CROSSROADS MIXED USE FILING NO. 2

CONSTRUCTION PLANS

V3_Construction Drawings_comments.pdf Markup Summary

SIGNAGE & STRIPING PLANS

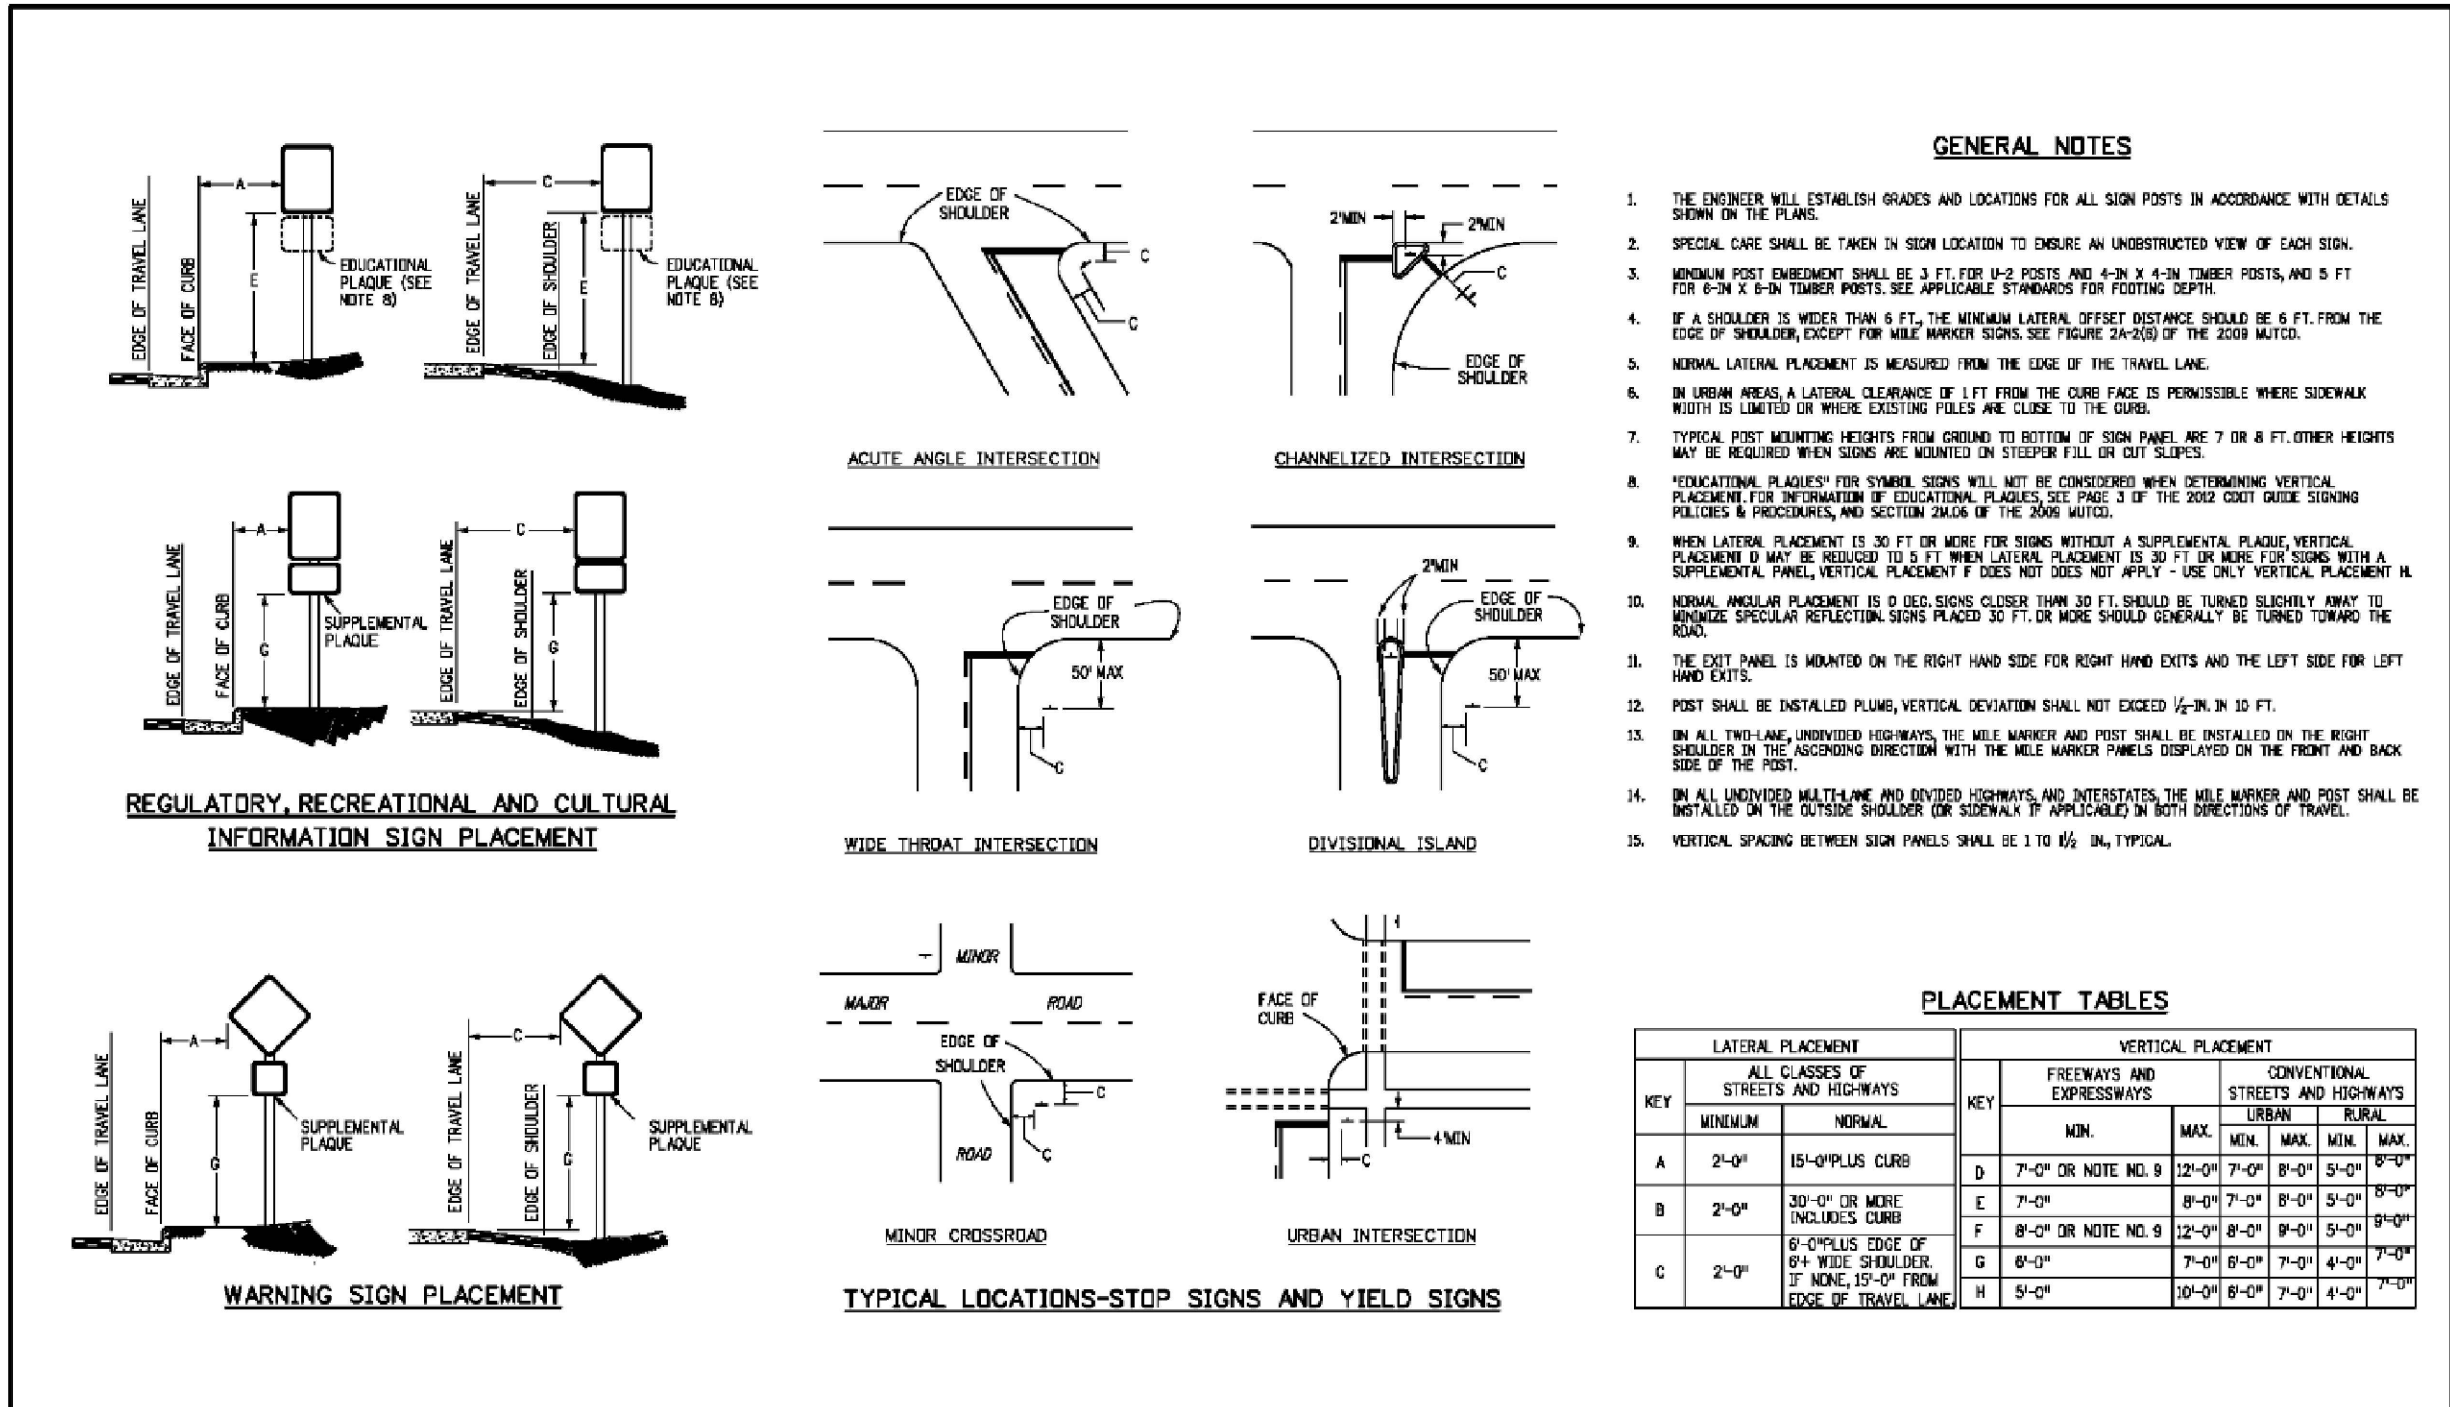
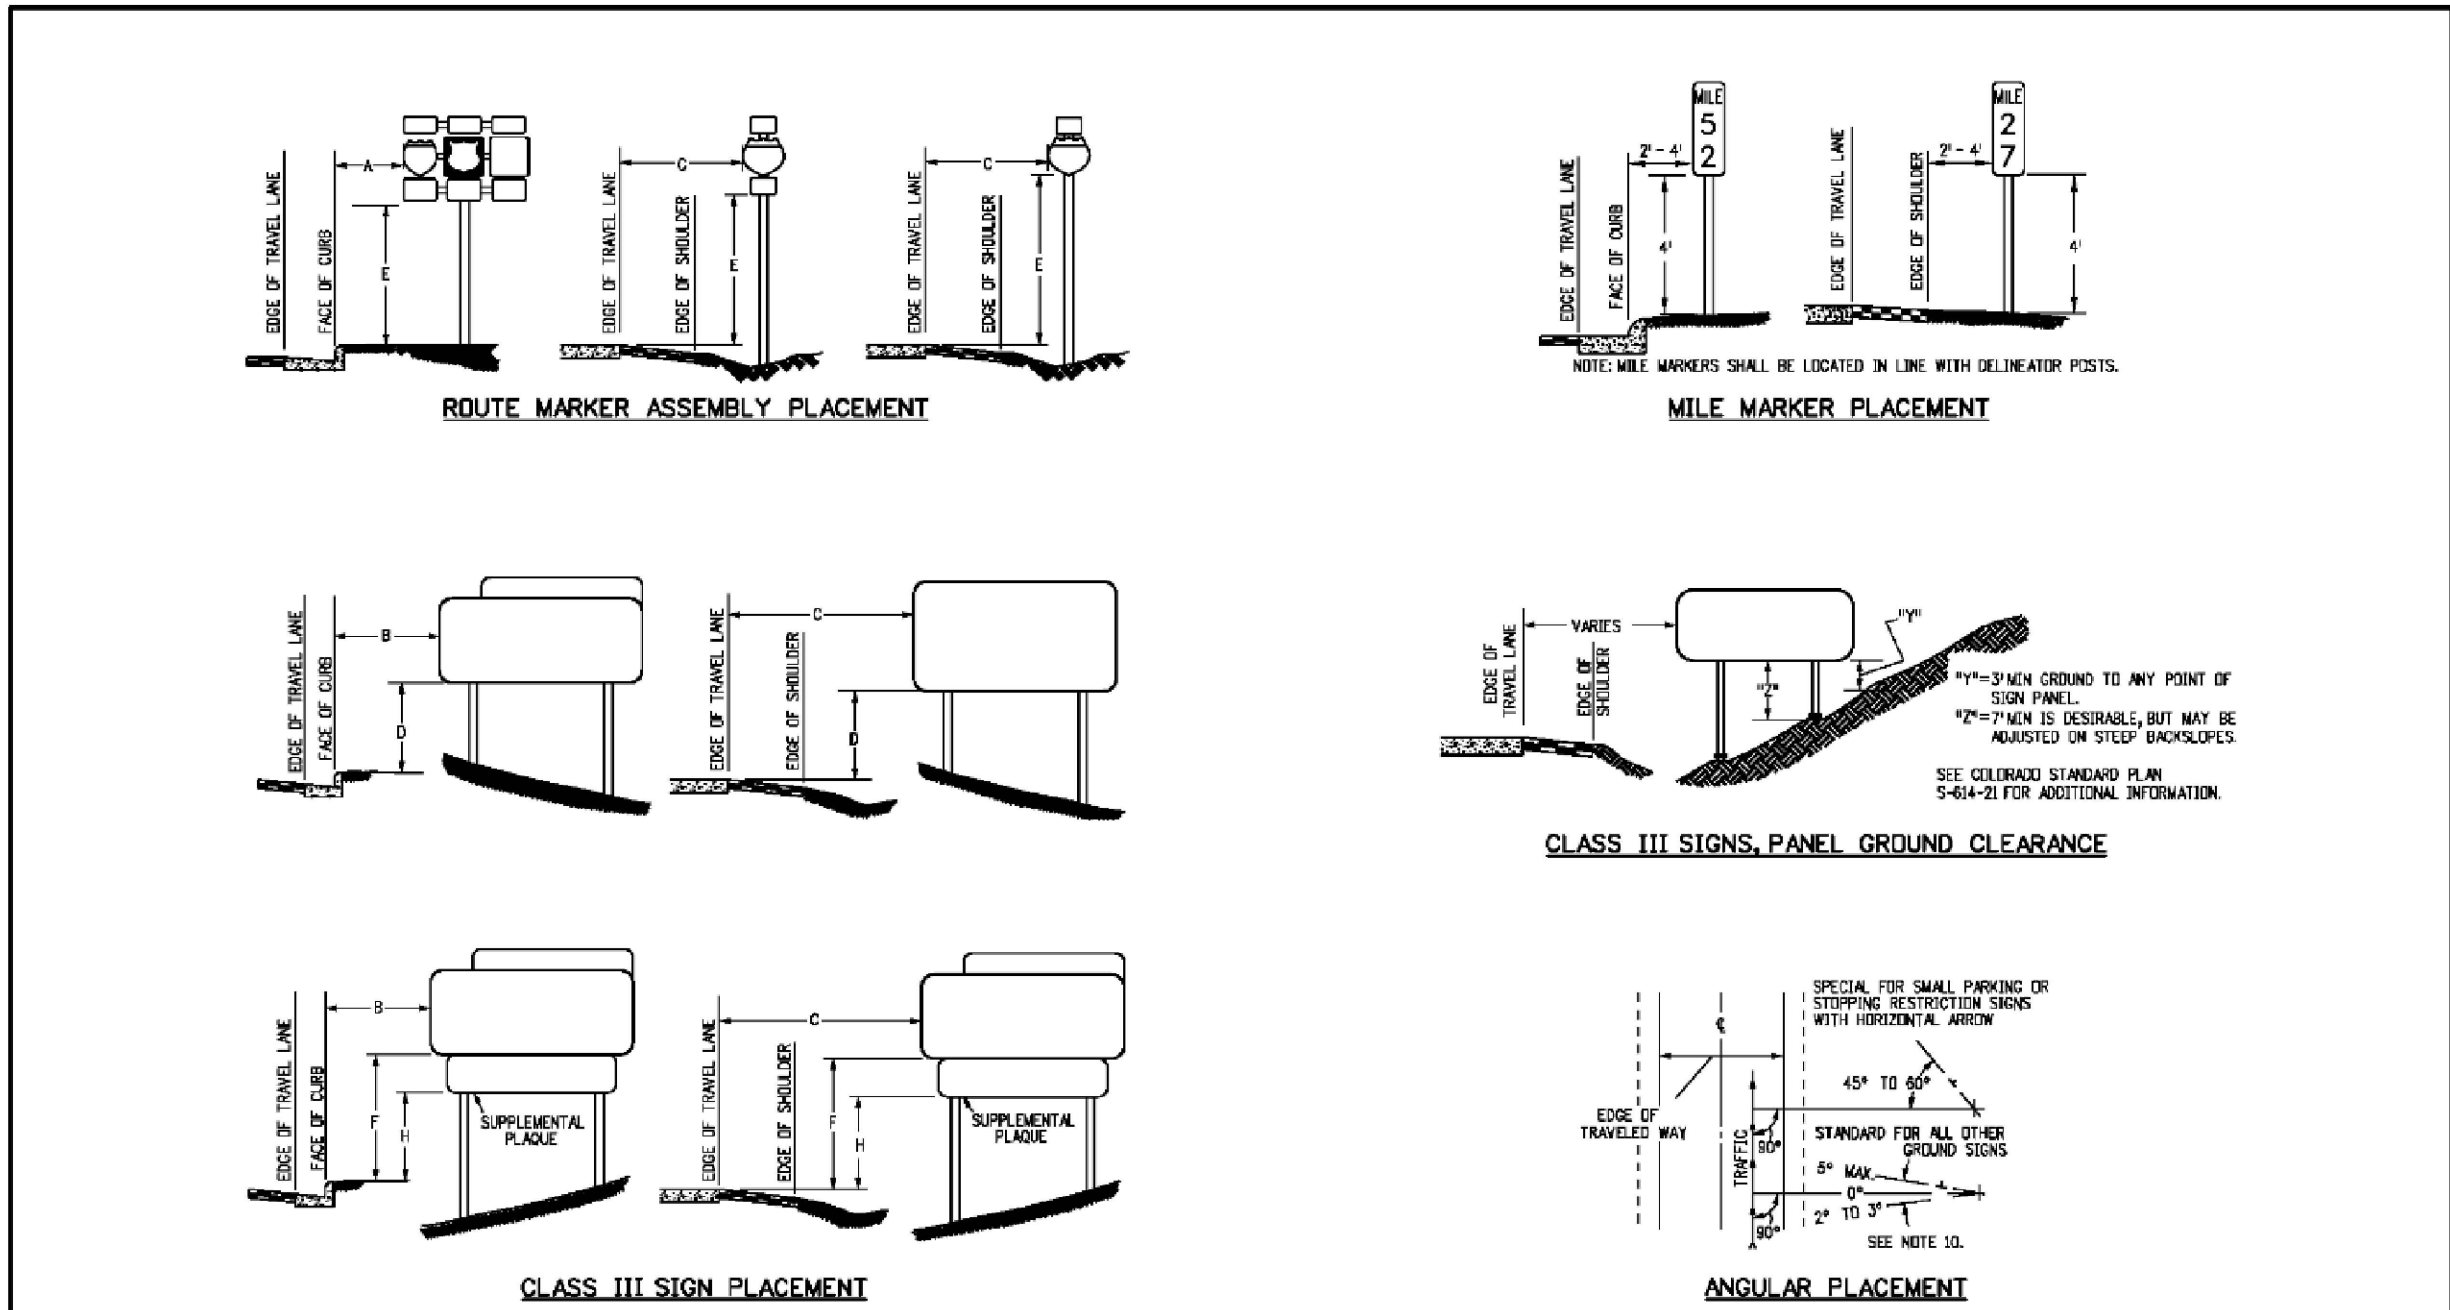
- Unresolved from review 1 and 2. update all proposed sidewalk alignment at the intersections per the county standard detail.
- Unresolved from review 1 and 2. Show/Install sidewalk along the east side of Southern Rail Point.
- The drawings have been updated to include a sidewalk all along the east side of Southern Rail Point.
- Deviation was denied. Please update to include sidewalk on appropriate places.
- Drawings have been updated to include the sidewalks on each side as in appropriate places with ramps.
- Unresolved from review 1 and 2. Per Aura at Crossroads see snippet. Revise to provide a sidewalk/crosswalk across proposed curb ramp per ECM 2.5.2.C.3 and 2.5.2.C.4.
- Sidewalks have been added to provide a crosswalk and ramp across the proposed curb. However, the located mentioned to connect to Aura at Crossroads is further south.

Unresolved from review 1 and 2. Show/Install sidewalk along the east side of Southern Rail Point.

Unresolved from review 1 and 2. Per Aura at Crossroads see snippet. Revise to provide a sidewalk/crosswalk across proposed curb ramp per ECM 2.5.2.C.3 and 2.5.2.C.4.

Unresolved from review 1 and 2. update all proposed sidewalk alignment at the intersections per the county standard detail.

Deviation was denied. Please update to include sidewalk on appropriate places.
